ARCHITECTURAL DRAWINGS

60 - 80 OXFORD STREET + 2A JAMES ST
WOOLLAHRA, NSW, 2025

SCHEDULE OF CHANGES
DA607/21

REVISION G - S34 AMENDMENTS

DEMOLITION PLAN - GROUND FLOOR

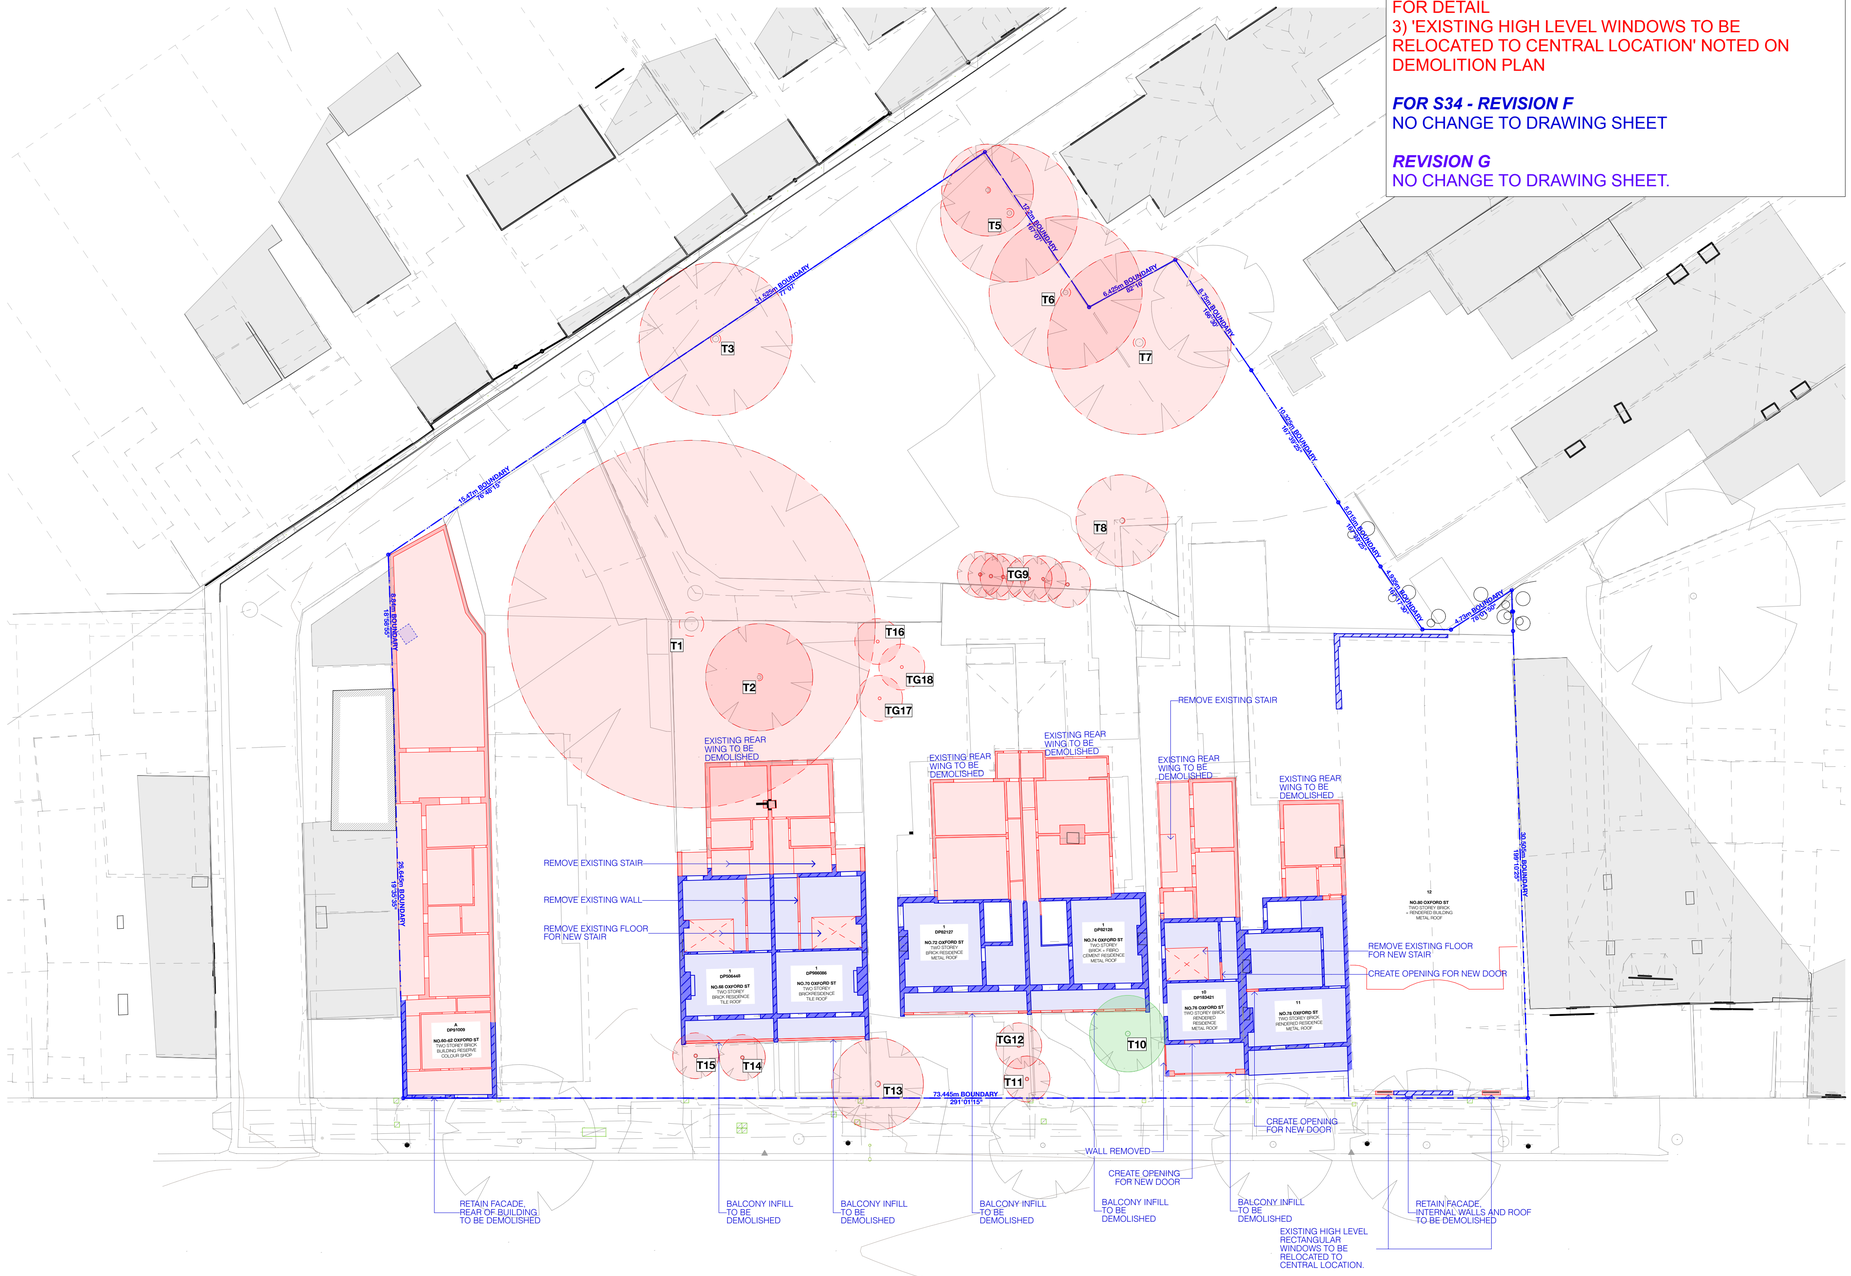
1) REAR BALCONY TO NO.68 AND NO.70 OXFORD TO BE REMOVED
2) T10 CABBAGE TREE PALM TO BE RETAINED OR RELOCATED ON SITE. REFER TO ARBORIST'S REPORT FOR DETAIL
3) 'REMOVE BRICK INFILL TO EXISTING ARCHED WINDOWS' NOTED ON DEMOLITION PLAN

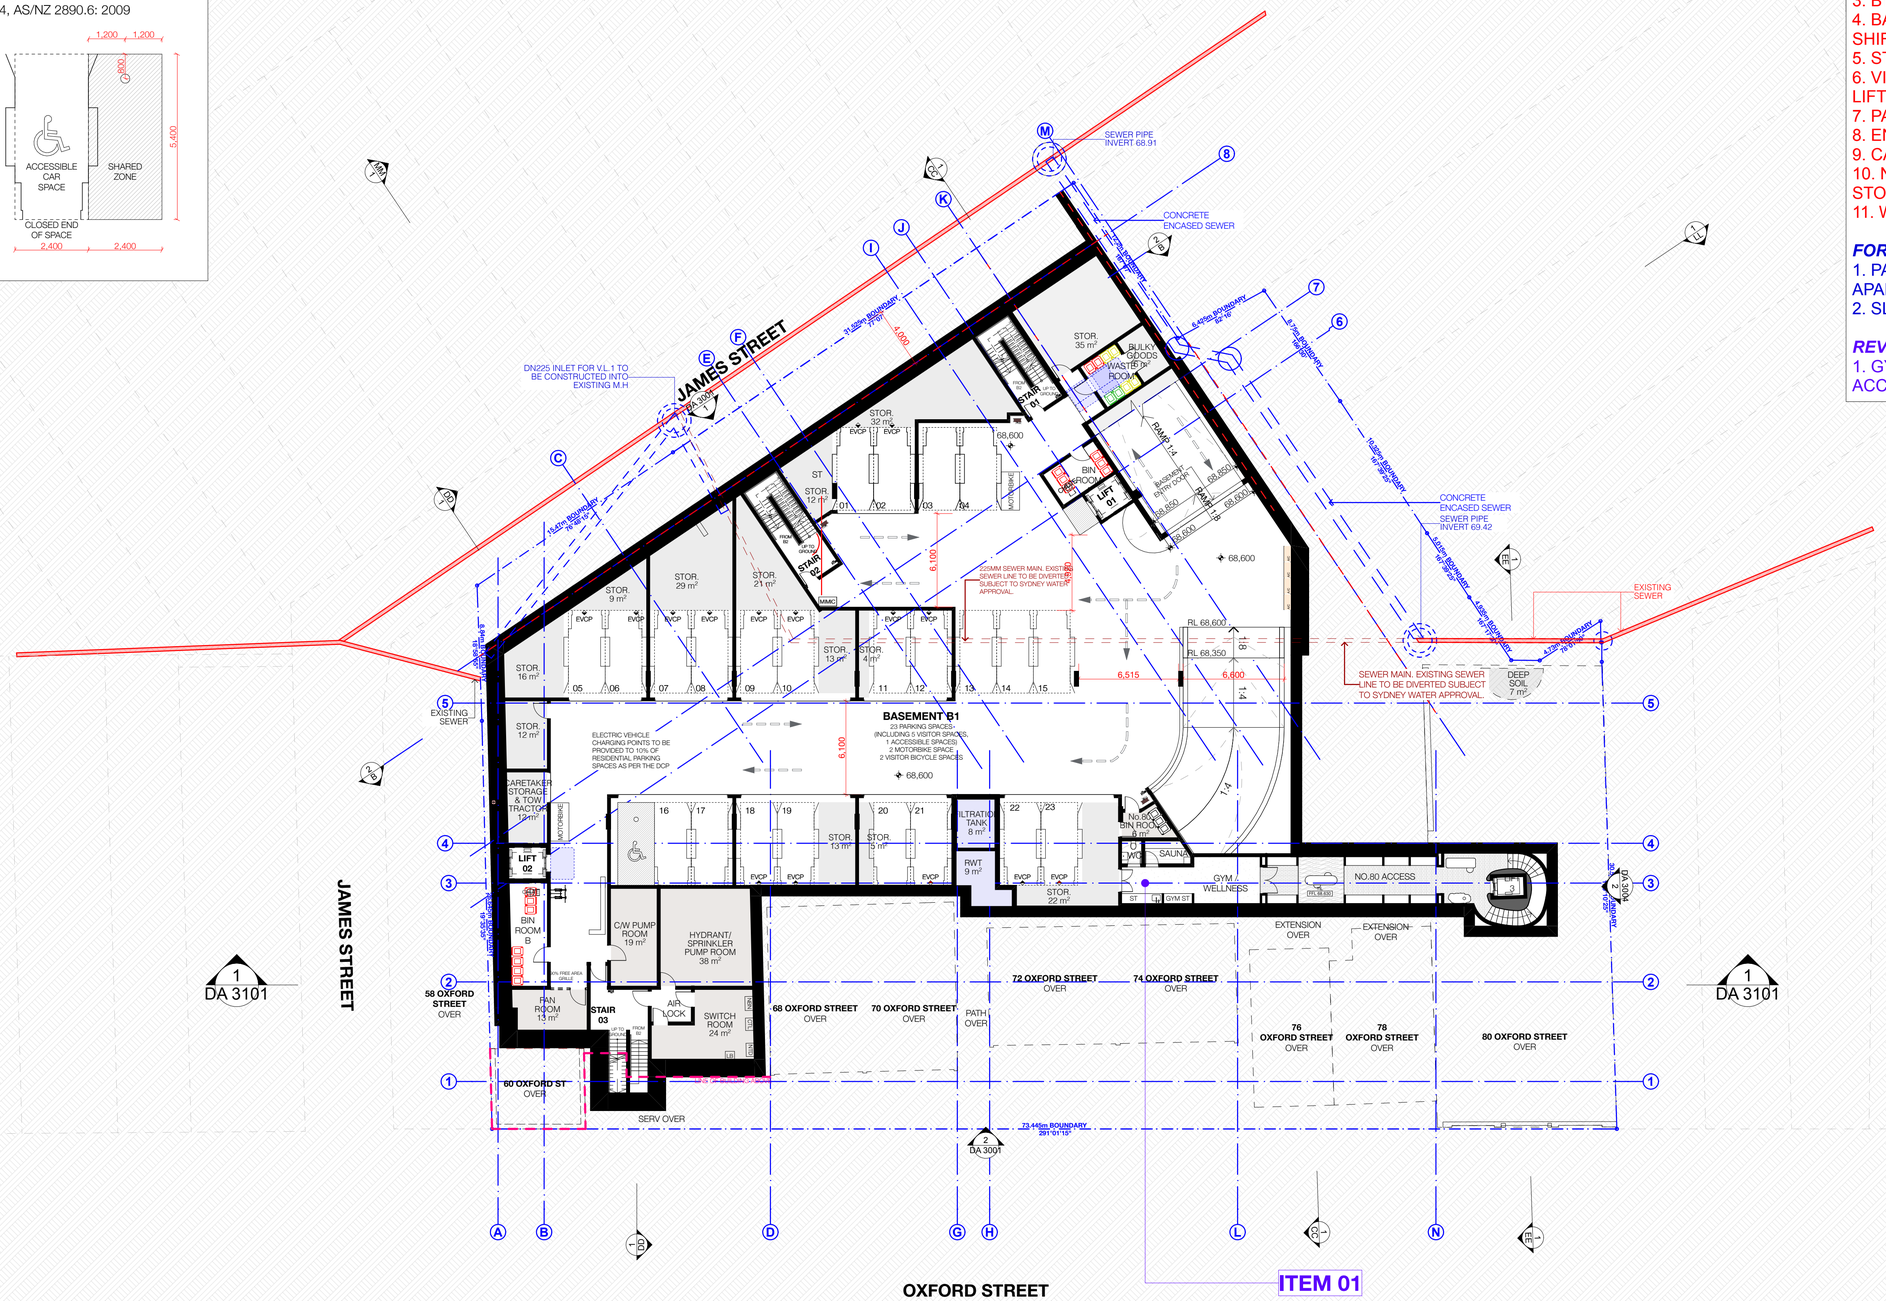
1. LIFT 01 AND 02 RELOCATED
2. OSD TANK CHANGED TO RAINWATER TANK AND RELOCATED
3. B1-B2 RAMP LAYOUT AMENDED
4. BASEMENT SHORING AMENDED, PARKING BAYS SHIFTED SLIGHTLY
5. STAIR 01 & 03 SHIFTED BASED ON NEW SHORING
6. VISITOR SPACE RELOCATED TO B2 DUE TO NEW LIFT 02 LOCATION
7. PARKING ALLOCATION AND NUMBERS AMENDED
8. ENTRY RAMP SHIFTED FOR SEWER CLEARANCE
9. CARETAKER STORAGE RELOCATED
10. NO.80 ACCESS INTERNAL DESIGN AMENDED, WINE STORAGE AND TOOL STORAGE ADDED
11. WASTE ROOMS RELOCATED UNDER ENTRY RAMP

NORTH ELEVATION - NO. 80 OXFORD STREET
1:100

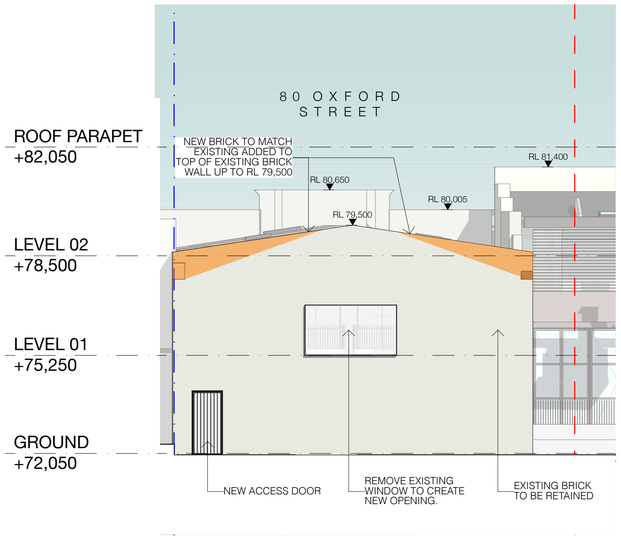
FOR S34 - REVISION F
1) **DA3006 NORTH ELEVATION (NO. 80 OXFORD STREET)** ADDED TO ADDRESS COUNCIL'S COMMENTS

SECTION AA
1:100

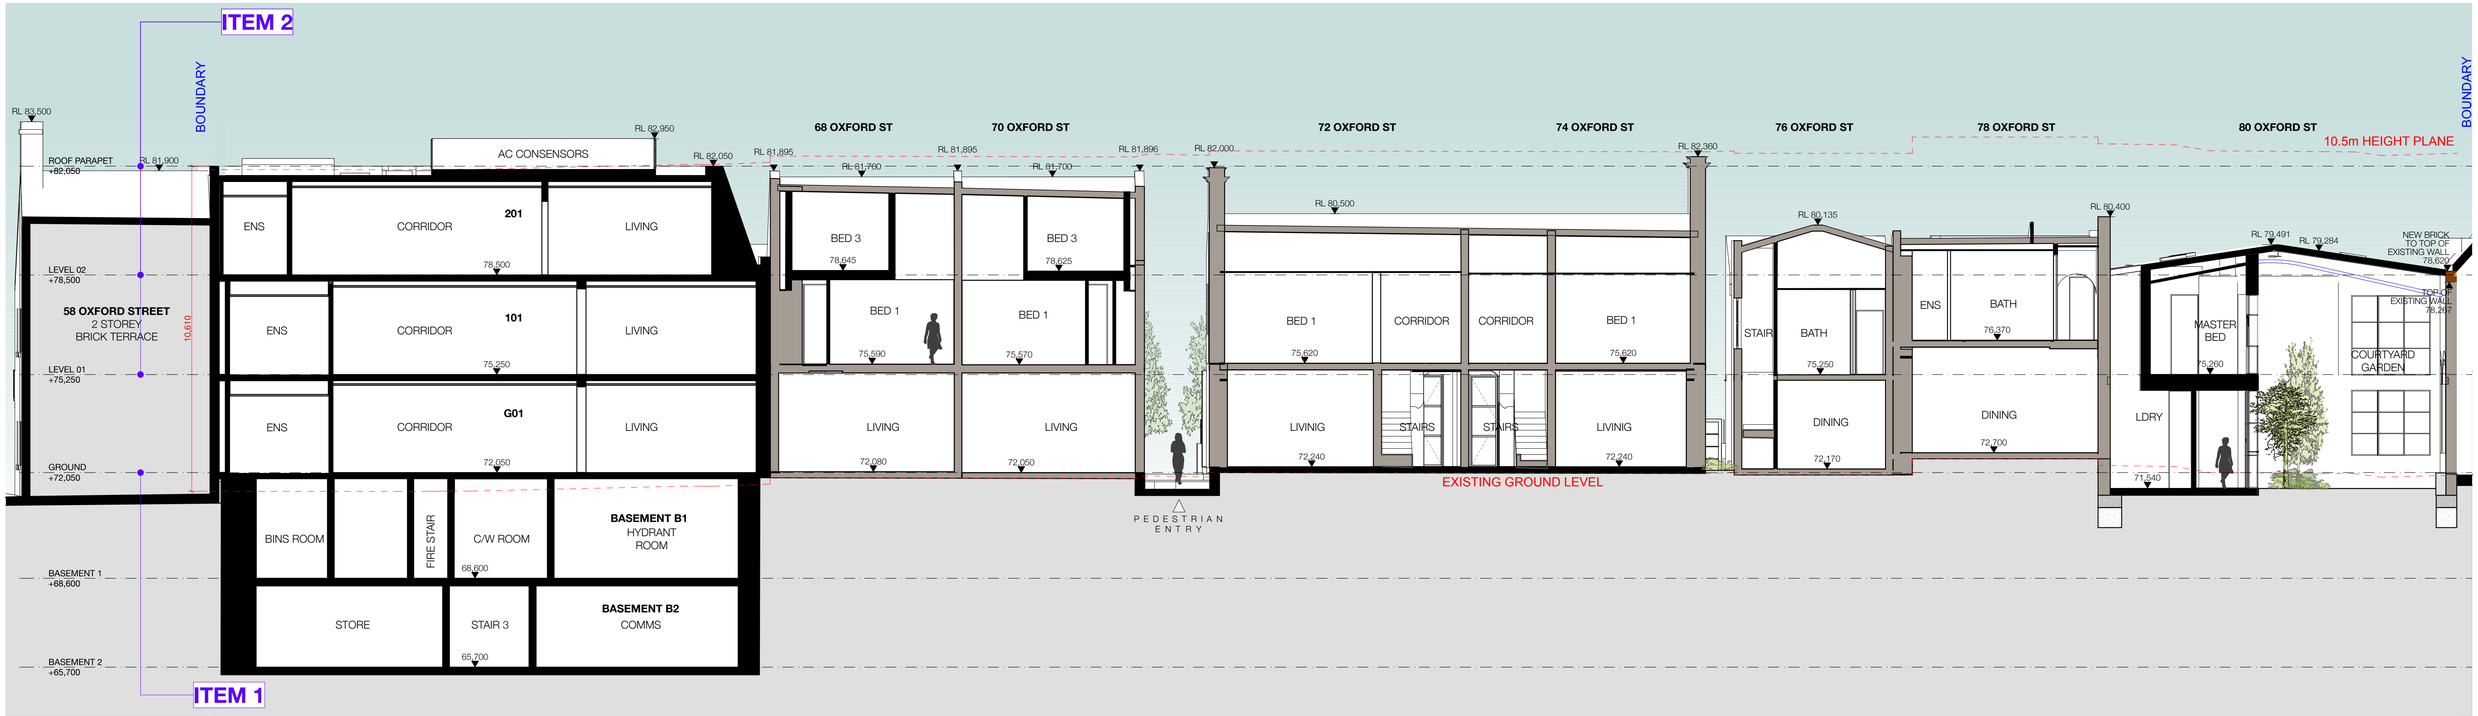
1. EXTENT OF MANSARD AMENDED
2. HEIGHT OF PARAPET AMENDED
3. ROOFTOP TERRACES ADDED

1. PLANTER OVER DRIVEWAY REMOVED
2. INTERNAL UNIT LAYOUTS AMENDED
3. PRIVATE TERRACES ON ROOFTOP REMOVED, AC AND HOT WATER PLANTS RELOCATED TO ROOFTOP.

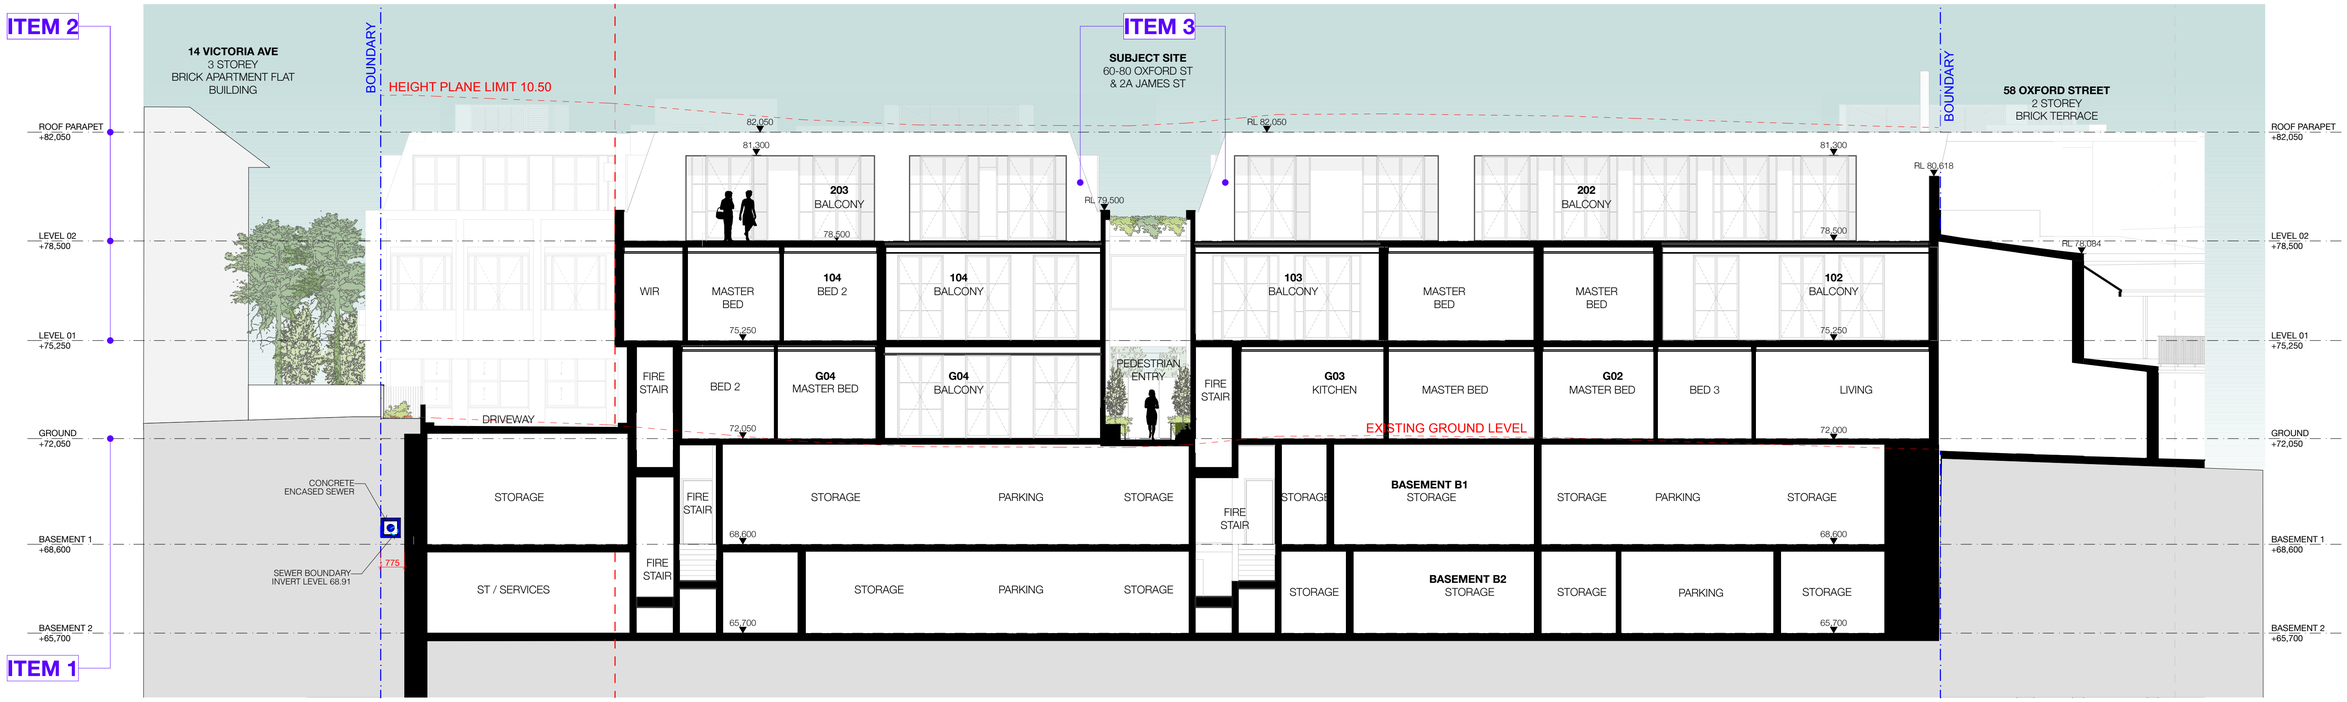
1. EXTENT OF MANSARD AMENDED
2. HEIGHT OF PARAPET AMENDED
3. ROOFTOP TERRACES ADDED
4. SECONDARY BALCONIES TO APARTMENTS CHANGED TO INTERNAL AREA, GFA ADDED
5. PLANTER OVER CARPARK ENTRY REDUCED
6. REAR EXTENSION TO #76 EXTENDED TO ALIGN WITH REARS OF OTHER TERRACE EXTENSIONS, ROOF PROFILE AMENDED

1. PLANTER AND BALCONY ABOVE DRIVEWAY REMOVED
2. TERRACES ON ROOFTOP REMOVED, AC AND HOT WATER PLANTS RELOCATED TO ROOFTOP
3. MANSARD REMOVED FROM REAR OF RFB FACING MEWS, PLANTER ADDED TO TOP FLOOR
4. DESIGN OF WINDOWS FACING RAMP AMENDED

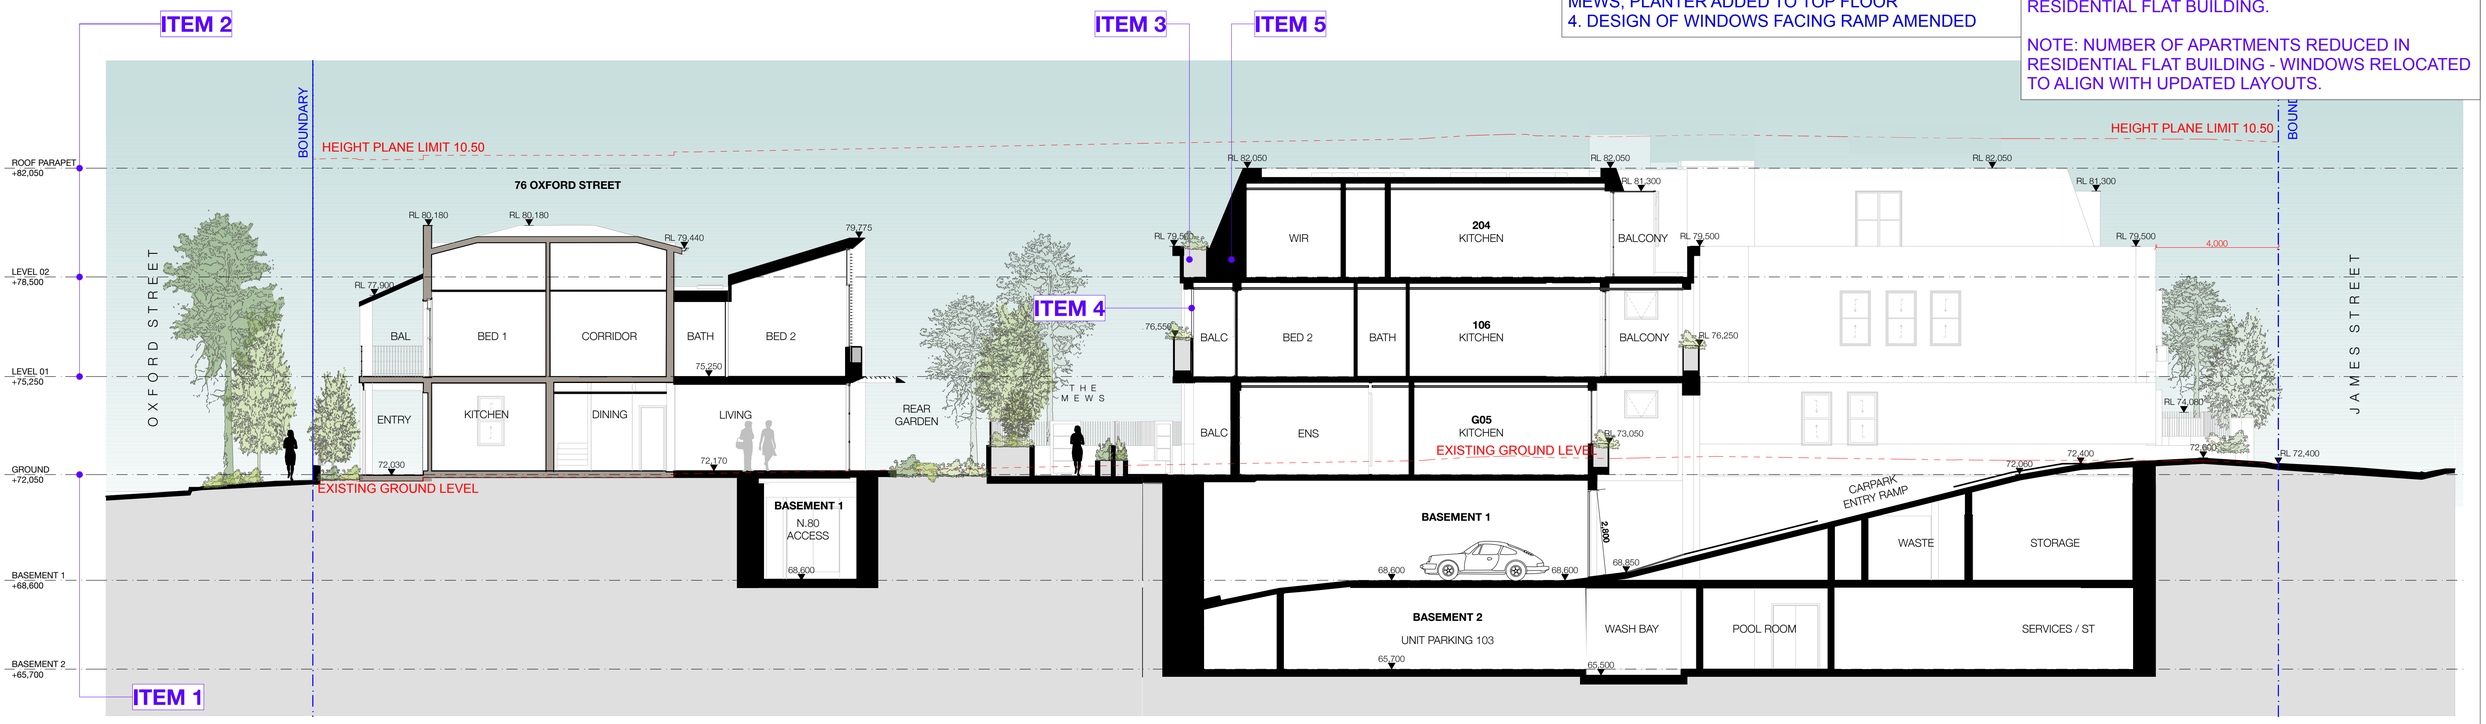
1. EXTENT OF MANSARD AMENDED
2. HEIGHT OF PARAPET AMENDED
3. ROOFTOP TERRACES ADDED
4. UNIT G01, 101, 201 BALCONY EXTENDED, ADDITIONAL INTERNAL AREA GIVEN BACK TO UNIT
5. BALCONIES TO JAMES ST REDUCED, AREA GIVEN BACK TO APARTMENTS, GFA INCREASED
6. LEVELS AMENDED TO ALIGN WITH REST OF APARTMENT BUILDING

1. TERRACES ON ROOFTOP REMOVED, AC AND HOT WATER PLANTS RELOCATED TO ROOFTOP
2. MANSARD REMOVED FROM REAR OF RFB FACING MEWS, PLANTER ADDED TO TOP FLOOR
